MEMORANDUM

To: The Design Advisory Board
From: Mary O'Neil, AICP, Principal Planner
RE: ZP18-0757CA; 131 Lakeview Terrace
Date: March 27, 2018

Request: Addition and renovation to historic single family home.

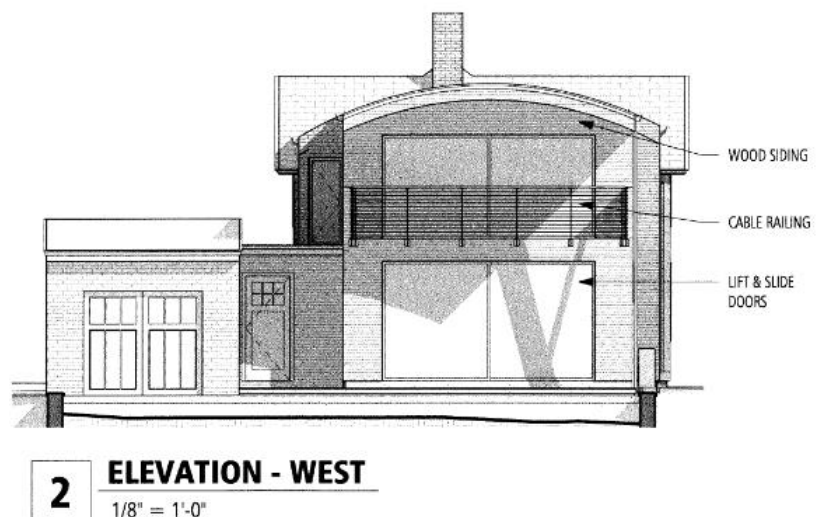
The existing single lane driveway and garage will continue to accommodate the required 2 parking spaces for the single family residence.
